**DEFENSE NUCLEAR FACILITIES
SAFETY BOARD**

DEFENSE NUCLEAR FACILITIES SAFETY BOARD

Staff Report

Review of the Los Alamos Plutonium Facility Documented Safety Analysis

Figure 3: Typical cluster of combustible objects for one Plutonium Facility laboratory room

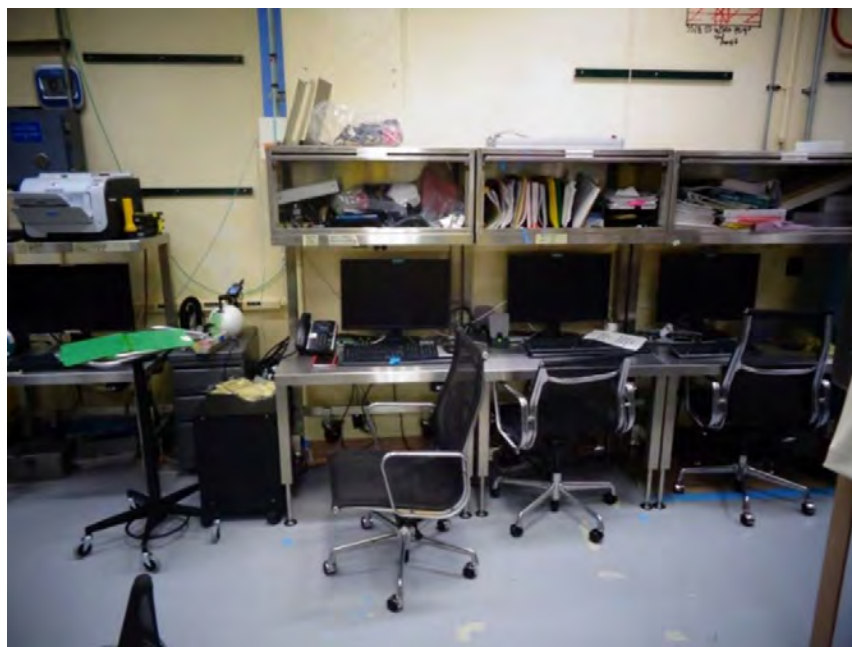
Combustible Loading Assumptions—One key assumption in an early stage of the LPF calculation process is determining the amount and arrangement of combustible material in laboratory rooms. Facility engineers perform walkdowns to determine and record the amount and location of combustibles in the facility. Each laboratory room is treated individually, and materials are grouped into "clusters" of chairs, desks, and nearby objects; engineers calculate which of those clusters would result in the highest Heat Release Rate (HRR) were it to catch fire. This information serves as the input to CFAST, which models the room temperature during a fire starting with that specific cluster, as well as the amount of time before the FSS actuates. Figure 3 shows a typical cluster for one laboratory room.

DOE Standard 3009-2014 states that “accident analysis relies upon well-founded assumptions that are protected at a level commensurate with their importance. TSRs [technical safety requirements] are used to protect the validity of significant assumptions.” Because the combustible loading assumptions directly affect calculated LPF values, which are credited to lower the dose consequences to the public, those assumptions should be protected with TSR-level Specific Administrative Controls (SAC). However, the submitted DSA does not include any such controls related to the amount and location of combustibles. The staff team specifically noted the following issues with not having combustible controls at the TSR level:

- There is no configuration control for the size of the analyzed fuel clusters. For example, additional furniture, computer equipment, or paper products could be added to a fuel cluster, changing the fire growth rate characteristics.
- Housekeeping in the Plutonium Facility is variable and depends heavily on the designated staff lead for work being performed in a given room. The Board’s staff has previously noted numerous instances of combustible trash or other items being left in disallowed locations for extended periods of time.
- Simultaneous ignition of multiple combustible clusters is not considered, even though that would be possible following a seismic event that disrupts electrical systems.
- Miscellaneous combustibles throughout laboratory rooms are not considered, even though they could shift during seismic events, serve as a “bridge” between clusters, or

otherwise increase the combustible loading in a meaningful way.⁷

Given operational and facility uncertainties (e.g., changing operational priorities, potential post-seismic equipment shifts) and the importance of combustible loading in calculations of public dose consequences, LANL and DOE should establish TSR-level controls on combustibles that would better protect key analytical assumptions.

Figure 4: Representative HRR vs. time curve for one Plutonium Facility laboratory room.

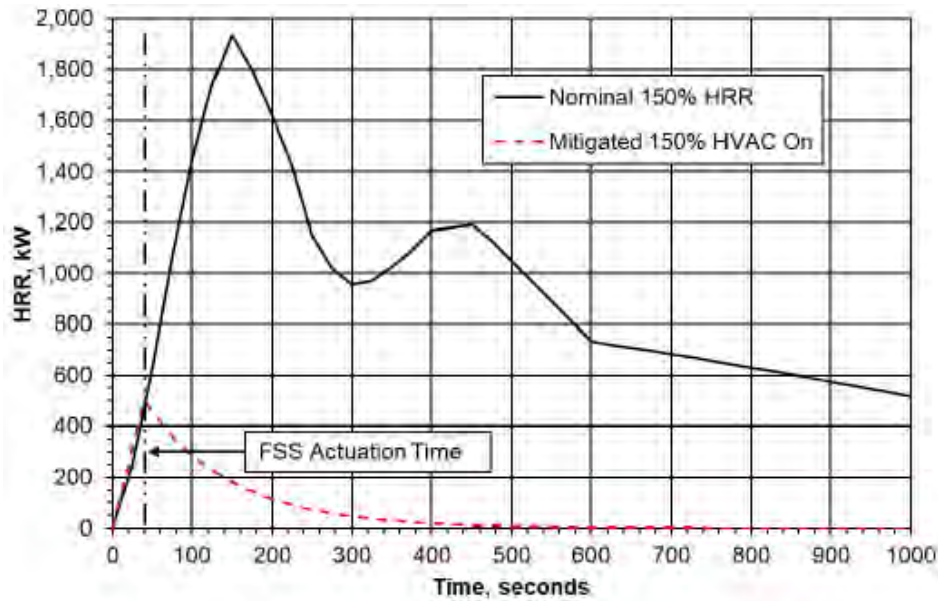
The solid black line represents the HRR associated with an unmitigated fire involving one cluster of combustible materials; the increases and decreases represent the ignition, burning, and extinguishing of individual items (each with different combustible characteristics), which add together to make the total curve. The red dashed line represents the HRR that LANL analysts calculated (using CFAST) following FSS actuation, based on the FSS characteristics (e.g., actuation temperature, water flowrate) input into the code.

The staff team noted during discussions that the significant downward slope of the red dashed line is not typical in safety analysis. Typically, an FSS like the one installed in the Plutonium Facility is assumed to perform a “control” function, for which the red dashed line would instead extend horizontally from the actuation point, rather than a “suppress” function, which is represented by the curve currently on the graph. This difference is illustrated in Figure 5 below.

LANL analysts stated that the Plutonium Facility FSS is designed in accordance with requirements in National Fire Protection Association (NFPA) 13, *Standard for the Installation of Sprinkler Systems*, for Ordinary Hazard Group 2 occupancies, consistent with “spaces with moderate to high quantity and combustibility of contents,” and is therefore able to deliver a minimum of 0.2 gallons of water per minute per square foot (0.2 gpm/ft²) [15]. Since the FSS is a credited safety class system, these design characteristics are protected in the TSRs. They further argued that the Plutonium Facility has a much lower level of combustible loading than typical Ordinary Hazard Group 2 occupancies (which could involve large amounts of wooden furniture, bookshelves, carpet, and other items that the Plutonium Facility does not generally contain). Since this FSS is designed to “control” a fire in a facility with significantly higher combustible loading, they stated that they were confident in the ability of the FSS to lower the HRR consistent with their analysis (i.e., the red dashed line in Figure 4).

However, the staff team noted that the trajectory of the HRR after FSS actuation—which follows from the 0.2 gpm/ft² flowrate assumption—relies on near-perfect energy transfer from fire to water, without any safety margin to account for unfavorable conditions or other inefficiencies. Water can pool or behave in other ways that do not directly contribute to removing energy from fires. Not accounting for these effects may result in an overstating of the true FSS efficacy. LANL did perform some scoping analysis of HRR as a function of lower FSS water delivery to reflect potential system degradation (e.g., only 50% of the water is delivered through sprinklers). LANL’s analysis of a generic room fire, taken from the combustible loading calculation updated after the staff team’s site visit, is shown in Figure 6 [16]. While this analysis was performed for a different purpose (and, as stated above, FSS characteristics are protected in the TSRs), carrying this analysis forward to determine LPF for those scenarios may be an appropriate method for adding appropriate safety margin.

Figure 5: Generic representation of the difference between control and suppression of fires.

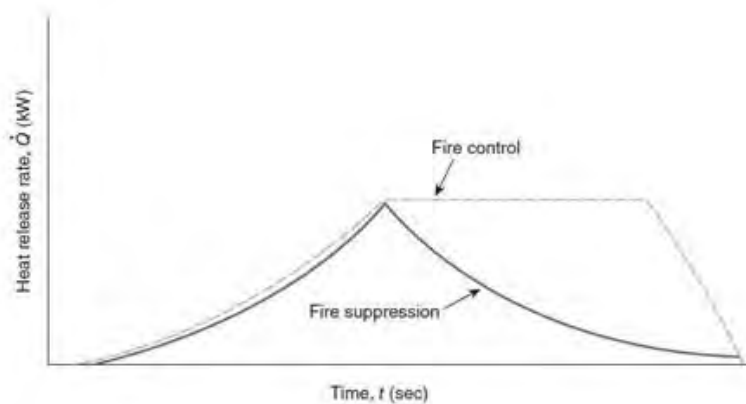
Without explicit design (such as deluge systems or inert gas systems), it may be inappropriate to assume the FSS behavior assumed in Figure 4, since it could overstate the efficacy of heat removal and therefore overstate the effects on calculated LPF and dose consequences.

Figure 6: LANL’s analysis of different throughputs of fire water—reflecting degraded FSS conditions—and the subsequent effects on HRR. This analysis could be extended as a method for adding safety margin to key LPF calculations.

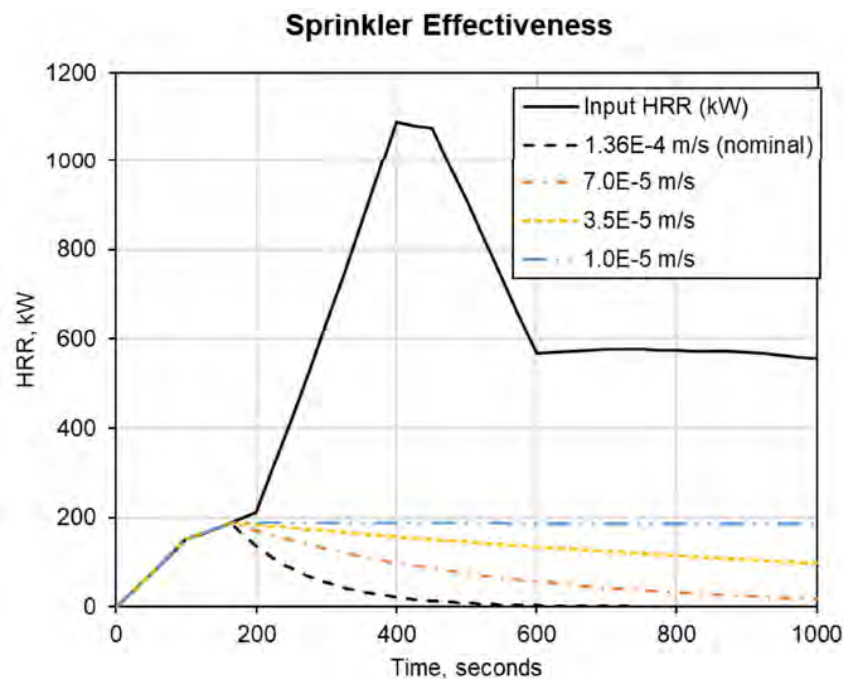
Additionally, the staff team noted that LANL’s combustible analysis does not adequately account for the possibility of fires occurring in locations where the FSS spray pattern may be impeded. This could also affect the assumed FSS actuation time and therefore also affect calculated dose consequences (e.g., fires could start underneath obstructions and burn for a time without heat flux directly being “seen” by sprinklers). During discussions, LANL analysts stated that, given the sprinkler coverage in the Plutonium Facility and expected spray patterns and angles, there would be few areas completely hidden from coverage. However, these conclusions are in part based on the facility configuration observed during walkdowns, rather than a generalized and conservative analysis of potential facility configurations. In a conservative safety analysis using a novel approach to crediting fire suppression, the staff team believes this possibility should be more comprehensively considered and accounted for.

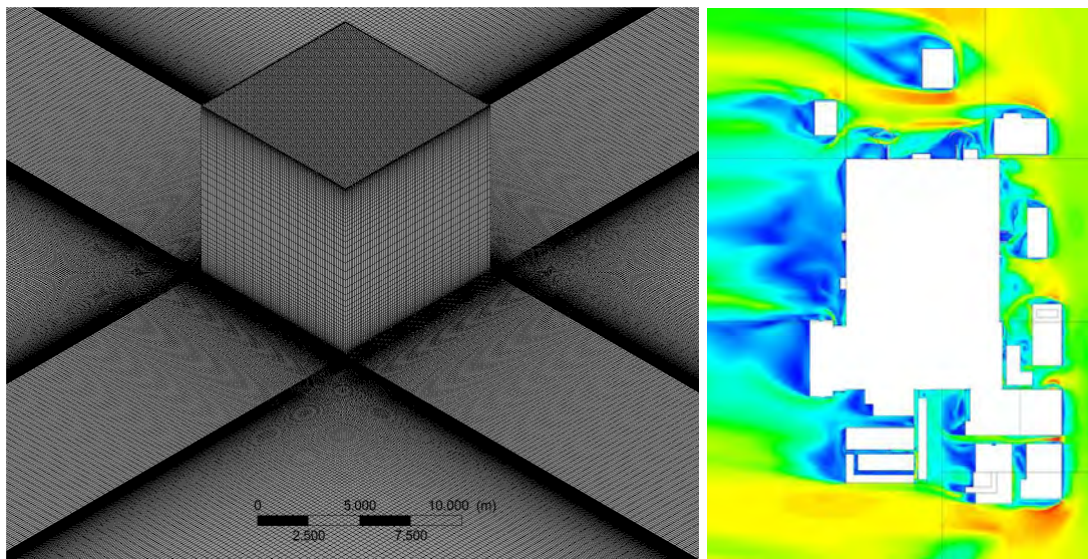
In other words, LANL created a simple geometric model to validate use of this CFD software, and that simple model did not fully align with experimental results as expected. Since good agreement could not be achieved with the simple cube model (pictured in Figure 7), the LPF values that are obtained using more complicated models also have questionable precision (an example of which is also pictured in Figure 7).

Plutonium Facility includes uncertainties in the grid size used (as shown in the grid refinement study) and in the modeling approach when compared against a standard cube model (as discussed above); feeding models with those uncertainties into further models in sequence creates the opportunity to compound existing errors, since mismatches between the boundary conditions of steady-state and transient models create additional opportunities for uncertainty propagation during handoff. An error propagation analysis—which is commonly done when several computer models are used in sequence—was not performed. LANL analysts agreed that there are opportunities for improvement in model handoffs.

Figure 10: Simplified diagram of the fire loop in TA-55. Following seismic events, non-nuclear buildings with lower seismic pedigrees must be separated from the loop to ensure water is delivered to nuclear facilities.

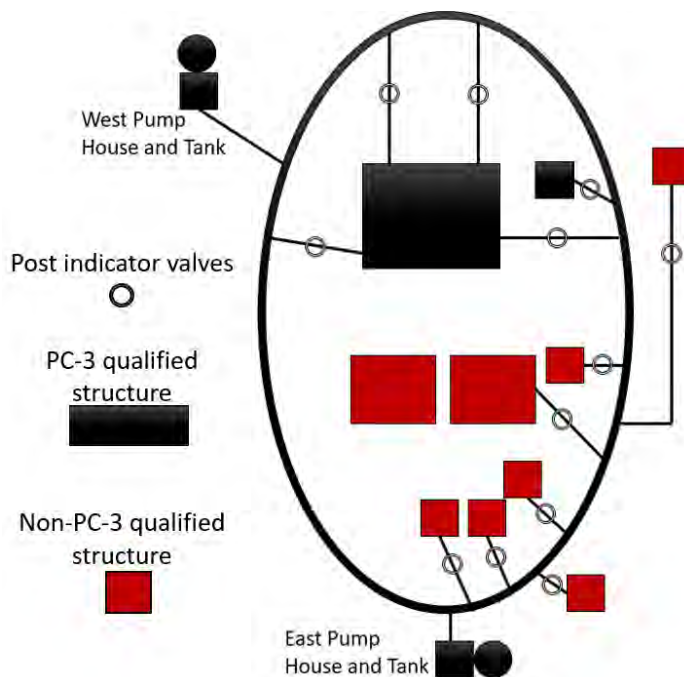
Fire Water Supply Loop Upgrades—As mentioned above, one ongoing project in TA-55 involves the supply of fire suppression water to the Plutonium Facility and other buildings. Many structures in TA-55, including nuclear and non-nuclear facilities, are connected to the same water supply. This creates a seismic vulnerability (demonstrated in Figure 10), since a break in the supply lines to non-nuclear facilities—which are not seismically qualified—could prevent water from being delivered to the Plutonium Facility. Personnel are working to install an alternate supply to non-nuclear buildings. Work on this project, which is tracked under facility operating funds, was expected to be completed in 2026; however, facility personnel stated that there were complications associated with the planned routing of the feed lines to the Plutonium Facility, which may cause delays. In the interim, preparatory work to facilitate separation of non-nuclear buildings from the common feed can still proceed. The final separation will not occur until after the new feed line is completed.

Currently, the Plutonium Facility DSA has administrative compensatory measures in place to account for this known vulnerability. Following seismic events, facility personnel are required to manually turn off the water supply to non-nuclear structures by closing a series of post-indicator valves located outside, in the TA-55 yard. While this action may ensure that the Plutonium Facility receives the required flow of fire suppression water, it is only appropriate as a

short-term solution as it (1) requires administrative actions by personnel in a post seismic environment which are less reliable than engineered systems, and (2) hampers the ability to fight fires in important non-nuclear buildings.
